XTO Permian Operating LLC Respectfully requests approval to perform the bradenhead squeeze in the intermediate 2 casing after fracing operations as per Figure D in the R-111-Q document. I have attached updated design in the email. There are no changes to proposed casing points & grades and cement program top in the approved APDs

R-111-Q: Potential Potash Pivot Well Design

Action 419280

Operator: XTO PERMIAN OPERATING LLC. 6401 HOLIDAY HILL ROAD MIDLAND, TX 79707	OGRID: 373075
	Action Number: 419280
	Action Type: [C-103] NOI Change of Plans (C-103A)

[Figure D] 4 String – Uncemented annulus between 1st and 2nd intermediate casing strings

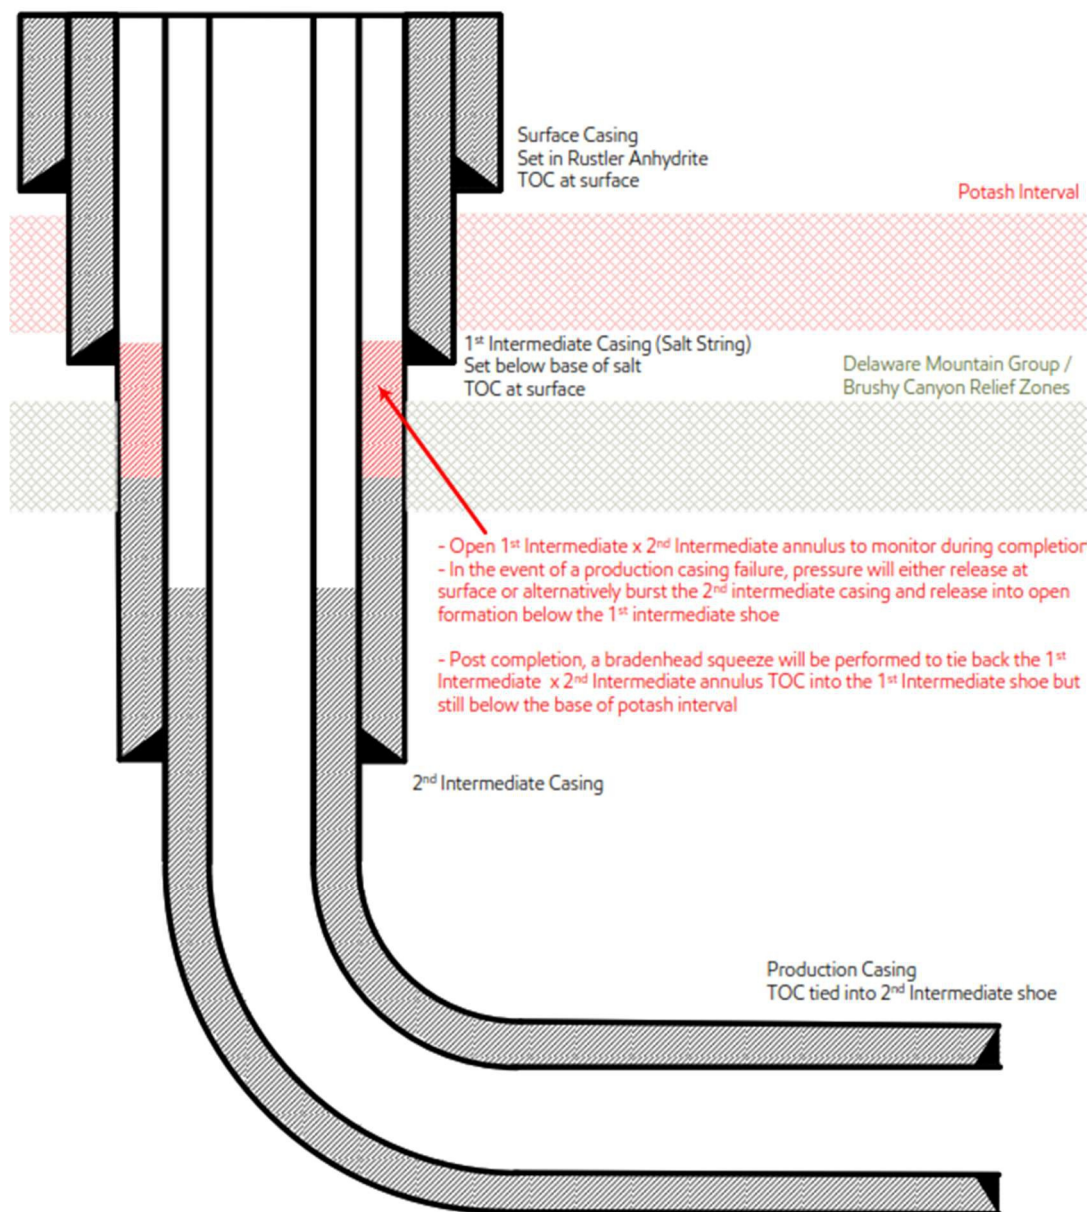
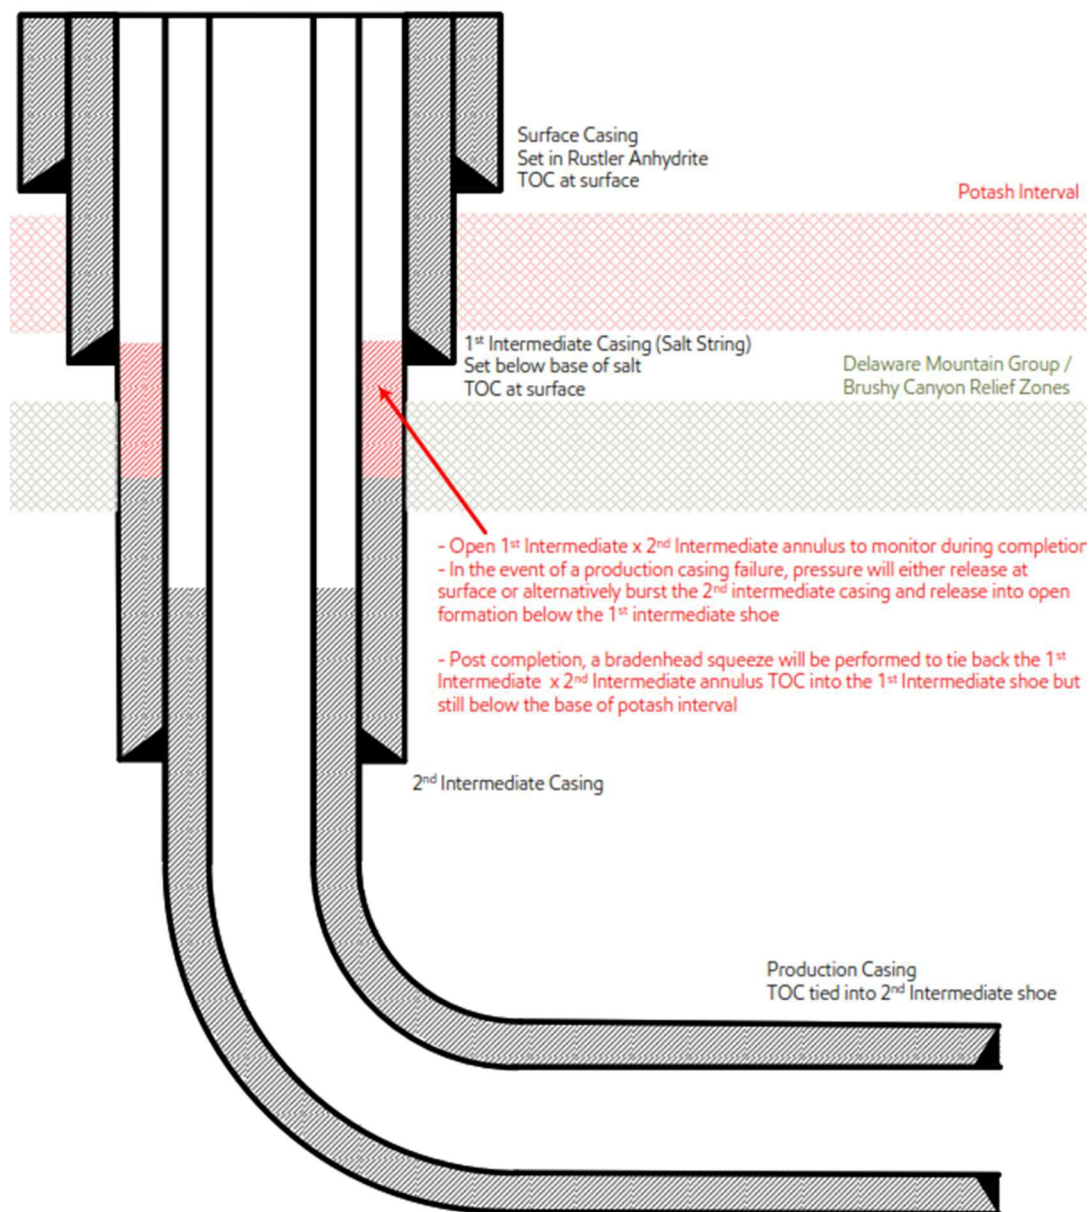
- 1) Alignment with KPLA requirements per schematic above, leaving open annulus open for pressure monitoring during frac and utilizing new casing that meets API standards.
- 2) Contingency plans in place to divert fluids away from salt interval in event of production casing failure.
- 3) Bradenhead squeeze to be completed within 180 days to tieback TOC to salt string at least 500ft but with top below Marker Bed 126.
- 4) Production cement to be tied back no less than 500ft inside previous casing shoe.

Created By	Condition	Condition Date
ward.rikala	Any previous COA's not addressed within the updated COA's still apply.	1/10/2025
ward.rikala	This well is within the R-111-Q potash area. The 1st intermediate casing string shall be cemented back to surface. Immediately following the cementing of the 2nd intermediate casing string, a CBL is required to document where the TOC is located. Immediately following the cementing of the production casing string, a CBL is required to document where the TOC is located. The bradenhead cement squeeze post frac shall provide a minimum of 500' of tie back into the 1st intermediate casing string.	1/10/2025

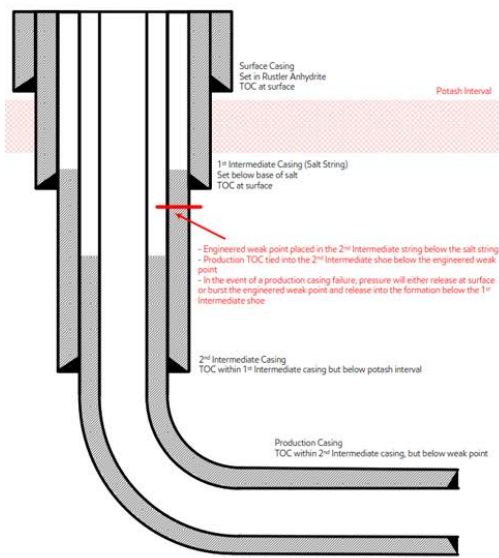
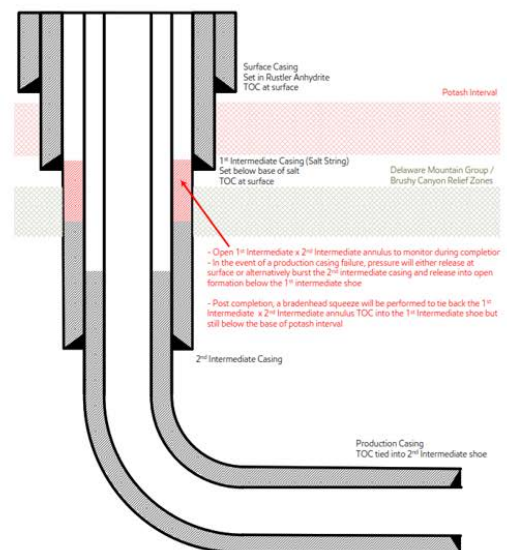
CURRENT 4-string design

POTENTIAL pivot 4-string design
